**NUMBER:** 19-003-15**GROUP:** Steering**DATE:** April 10, 2015

Intermittent Power Steering Noise And/Or Slight Loss Of Assist

2015 (LA) Dodge Challenger

**Fig. 1 Underhood View**

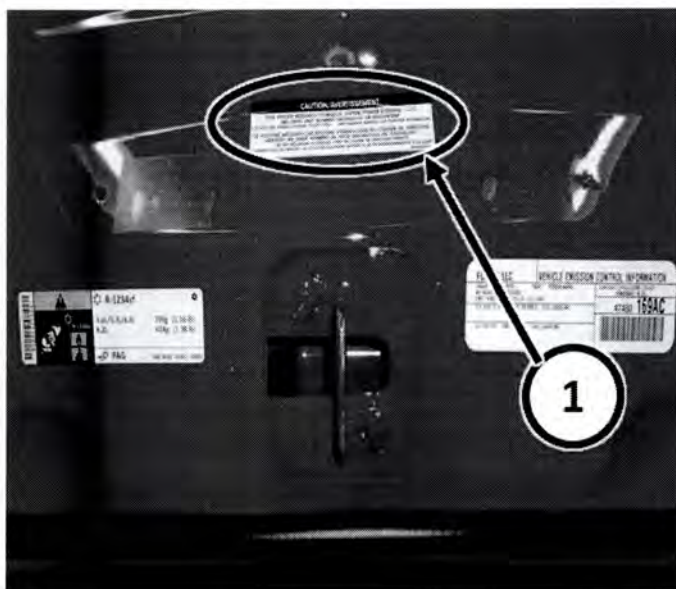
- Install the low pressure return line and tighten to 38 nm (28 ft lb).
- Install the belly pan. Refer to the detailed service procedures available in DealerCONNECT/TechCONNECT Service Info section 13 - Frame and Bumpers> Under Body Protection> BELLY PAN, Engine> Installation.
- Fill the system with the specified MS-10838 (pn# 68234631AA) fluid and bleed the system of all air. Refer to the detailed service procedures available in DealerCONNECT/TechCONNECT Service Info section 19 - Steering> Standard Procedure> Power Steering System Bleeding.
- Install the new power steering caution label under hood. Refer to (Fig. 1).

1 - Power steering label installation location.
